TO: *mf* Marco Foster, MS473 54
THRU: *TRM* T. Madden / K. Klingman, NB82-230
FROM: *PF* P. Fuller / S. Beadle, NB 82-66
SUBJECT: C8 549
SR99, AWW Replacement North Access Connection
F.A. Project No: STPF-0099(122)
CHANGE ORDER 125
EN6, EN3A & EN3B Ductbank Changes

**WASHINGTON STATE
DEPARTMENT OF TRANSPORTATION
CHANGE ORDER**

CONTRACT NO: 008549 FEDERAL AID NO: STPF-0099(122)
 CONTRACT TITLE: SR 99, ALASKAN WAY VIADUCT - REPLACEMENT NORTH ACC
 CHANGE ORDER NO: 125 M-1, EN6, EN3A, EN3B DUCTBANK CHG

PLAN REF. NO.
 UPR10A
 SHEET
 228A
 OF
 770
 SHEETS

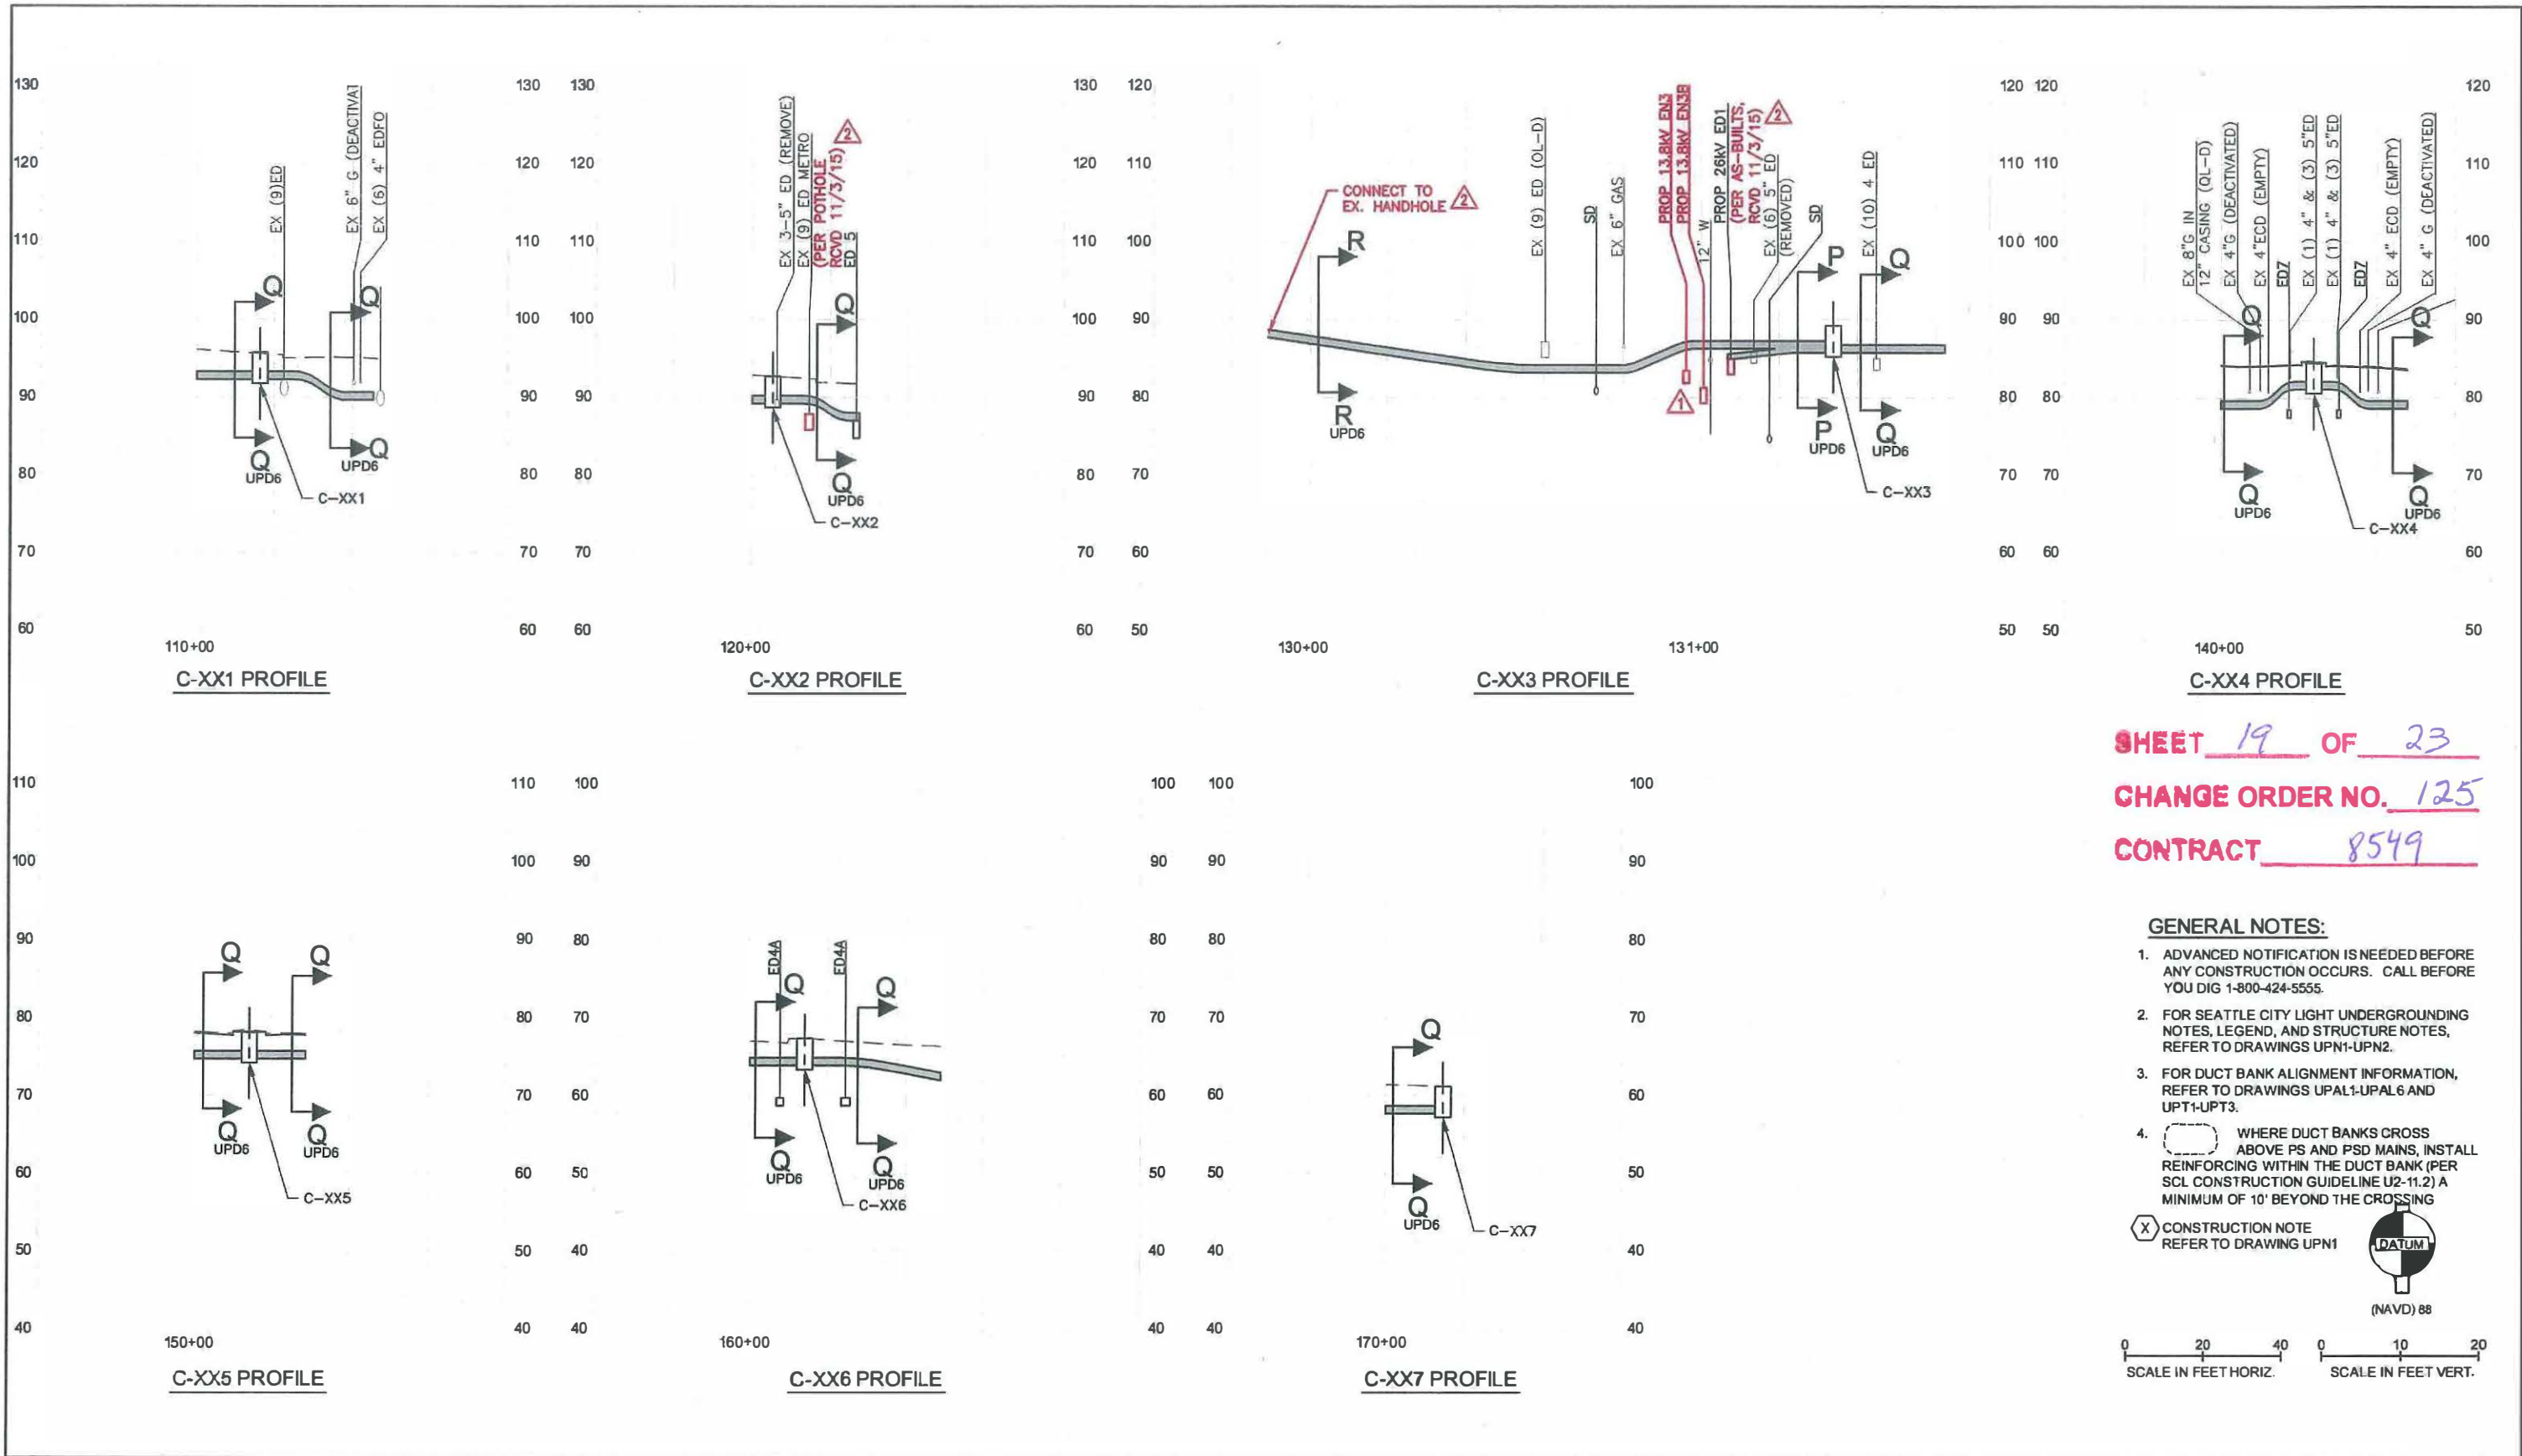
Adds new ductbank EN6 from station EN6 260+00.00 to 262+20.20 as shown on plans sheets UPAL1, UPT3, UP1, UP9, UP16, UPR2-UPR3, UPR7, UPR10A, UPD10, and UPD28. This work consists of excavation and shoring, procuring ductbank materials and installing them, placing high strength FTB, forming materials, setting forms and stripping, placing low strength FTB, chipping overpour at existing V-834, coring at V-834, dirt export and disposal, vactoring, dewatering the excavation area, 2ft overexcavation of trench and placing quarrying spalls and bedding, importing quarry spalls and bedding, supporting existing utilities which involves crossing live ductbanks at Harrison St. vicinity and supporting existing foundations, mobilization and demobilization of equipment, survey and cleanup.

PLAN REF. NO.	UPD10
SHEET	240
OF	770
SHEETS

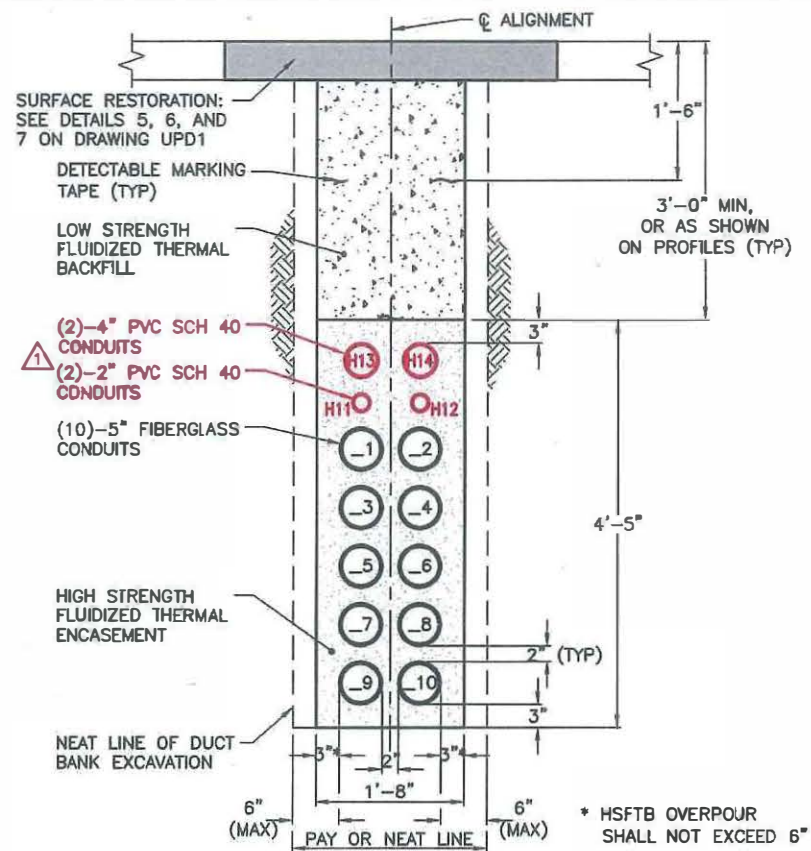
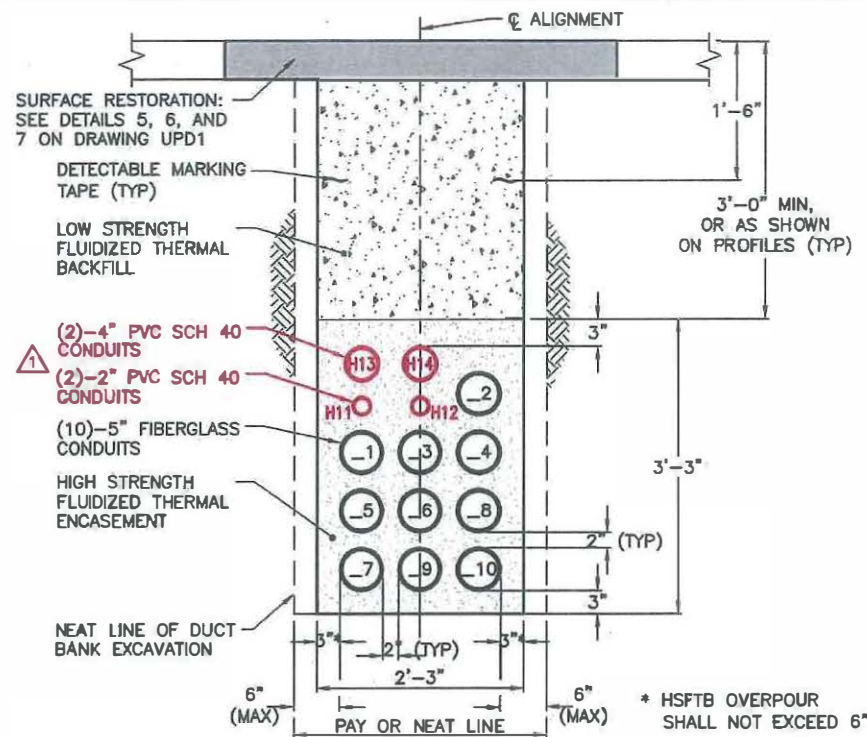
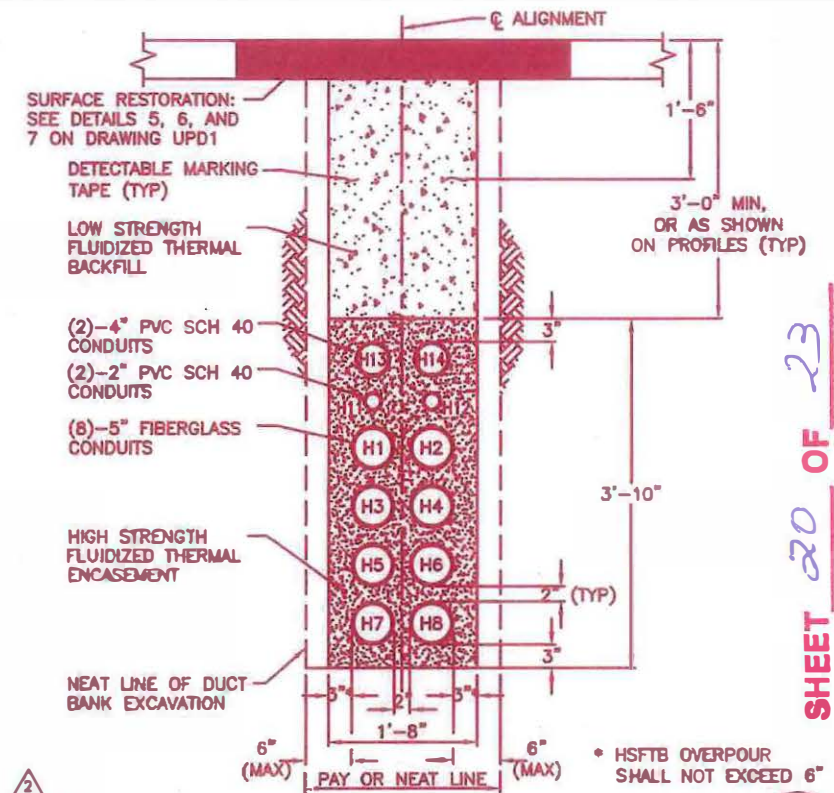
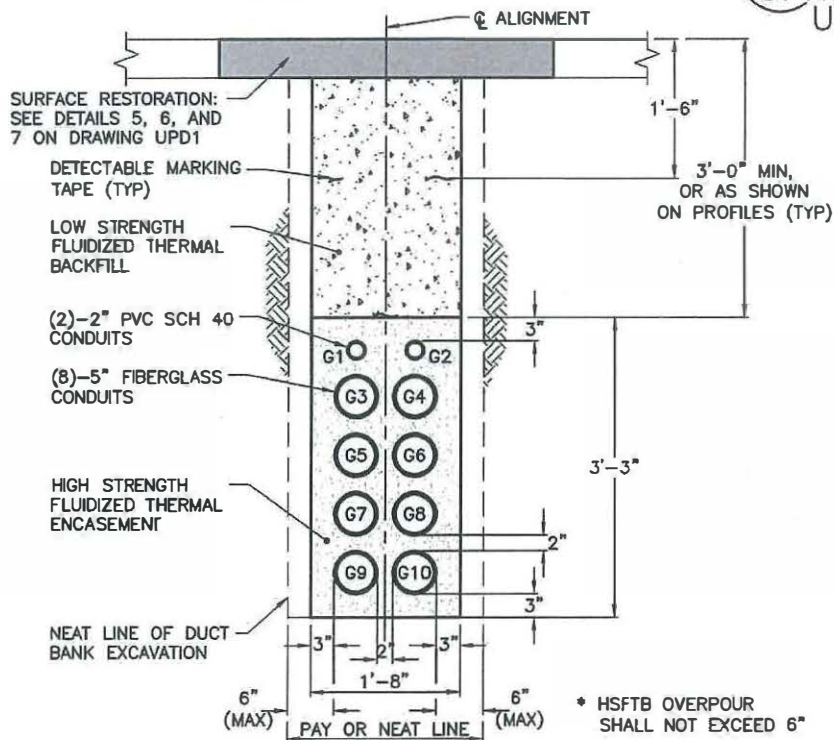
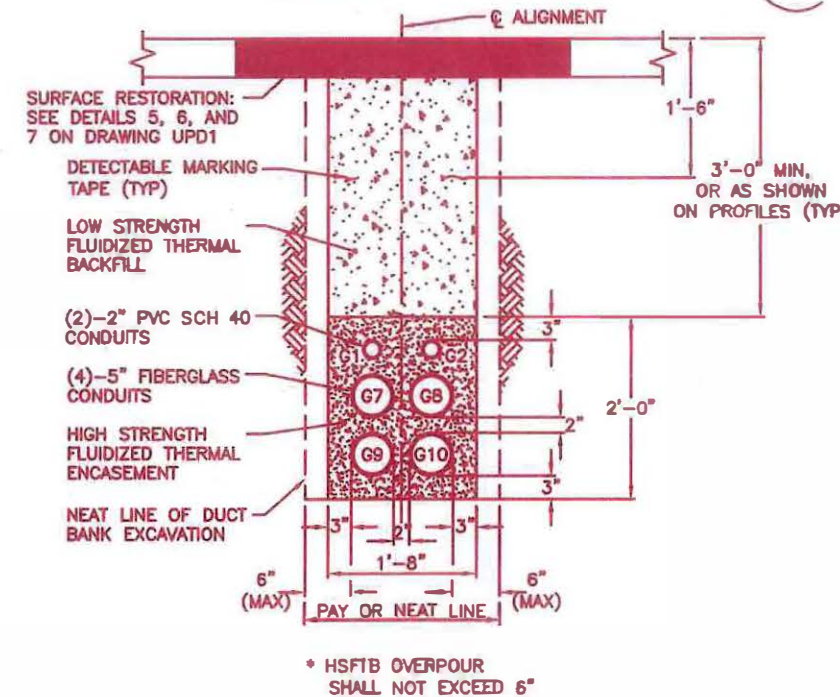
Adds new ductbank EN3A from station EN3A 238+00.00 to 238+50.03 and adds new ductbank EN3B from station EN3B 239+00.00 to 239+43.37 as shown on plan sheets UPAL1, UPT3, UP1, UP9, UP16, UPR1, UPR9, and UPD10. This work consists of excavation and shoring, procuring ductbank materials and installing them, placing high strength FTB, forming materials, setting forms and stripping, placing low strength FTB, dirt export and disposal, vactoring, dewatering the excavation area, supporting existing utilities and existing foundations, mobilization and demobilization of equipment, survey and cleanup.
